[Docket No. FAA-2022-0891; Project Identifier AD-2022-00585-A,E,R; Amendment 39-22432; AD 2023-09-09]

Airworthiness Directives; Various Airplanes, Helicopters, and Engines

Final rule.

Figure A

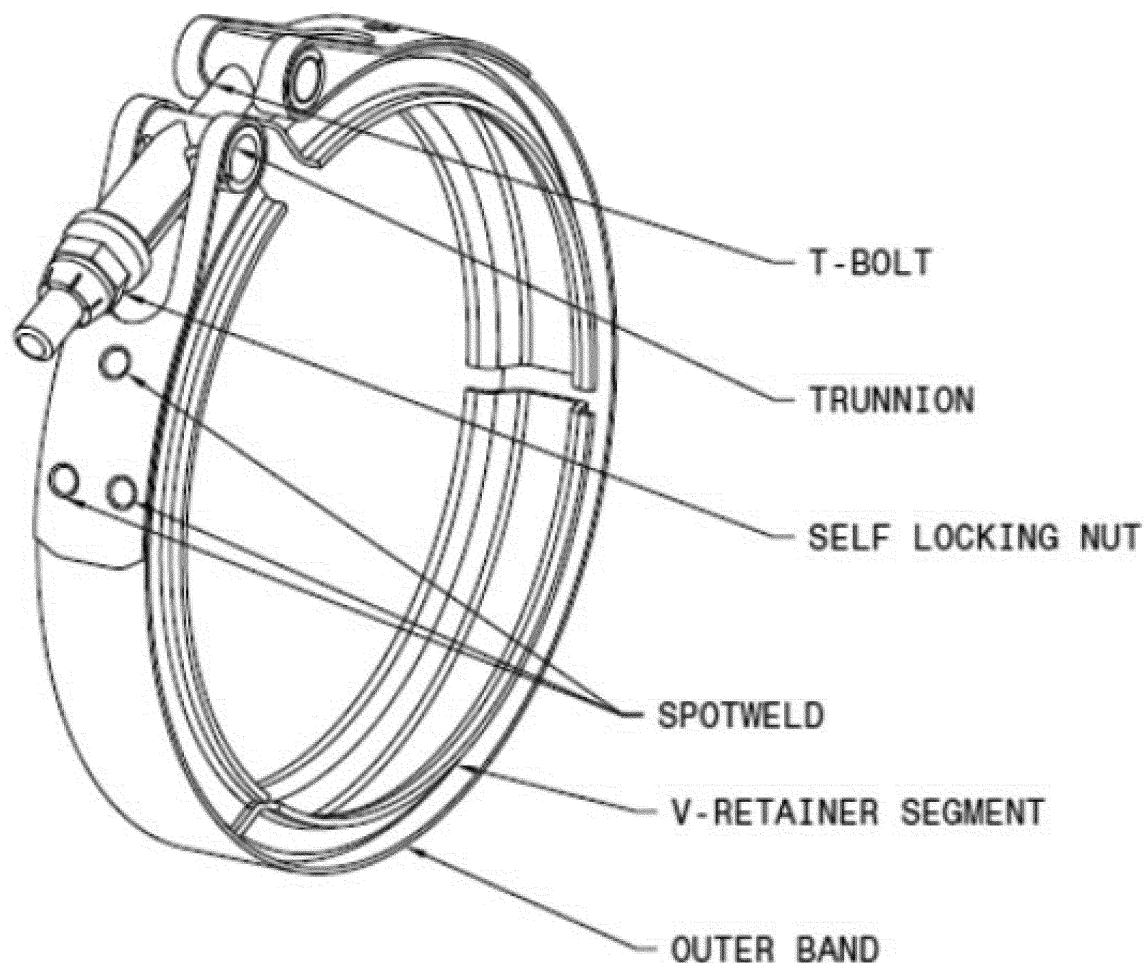
One individual commenter stated that instead of being spot-welded, the rings (v-band couplings) should be solid state welded. This commenter researched spot-welded couplings that revealed if the heat and pressure on the metal prior to the spot-weld is not consistent, the spot-weld will fail. Another individual commenter stated that spot-welds are good in tension and not in shear. The commenter further explained that as the v-band coupling is tightened, the spot-weld is in shear, and that adding dynamic loads reduces the spot-weld's life even further. This commenter suggested that a different type of attachment be used such as a braze joint or a laser weld.

An individual commenter stated that during manufacturing, the single spot-welds might be placed too close to the trunnions, thereby causing failure points. This commenter suggested using a total of four spot-welds instead of two spot-welds. The FAA infers that the commenter is requesting a change to the manufacturing of the v-band coupling.

The FAA has determined that inspections, in combination with life limits, are sufficient to mitigate the risk. The FAA would consider any future design improvements as an AMOC request following the procedures outlined in paragraph (n) of this AD. Regarding the proposed revision to AC 43.13-1B, that

Figure 1 to paragraph (l)(1)(iii) – Inspection Depiction

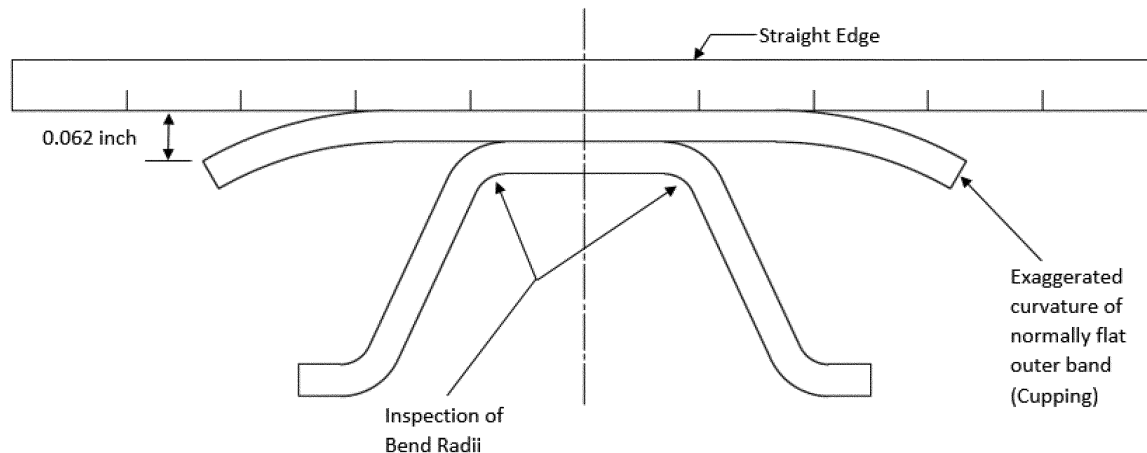
(4) Inspect the v-band coupling outer band for cupping, bowing, and crowning as depicted in figure 1 to paragraph (l)(1)(iii) of this AD. If there is any cupping, bowing, or crowning, before further flight, remove the coupling and, instead of the inspections in paragraphs (k)(5) through (7) of this AD, do the inspections in paragraph (l) of this AD.

(iii) Visually inspect the flatness of the outer band using a straight edge. Lay the straight edge across the width of the outer band as depicted in figure 1 to paragraph (l)(1)(iii) of this AD. If the gap between the outer band and the straight edge exceeds 0.062 inch, before further flight, remove the v-band coupling from service and install a new v-band coupling.

(v) Visually inspect the bend radii of the v-retainer coupling segments, throughout the length of the segment, as depicted in figure 1 to paragraph (l)(1)(iii) of this AD, for cracks. If there are any cracks, before further flight, remove the v-band coupling from service and install a new v-band coupling.
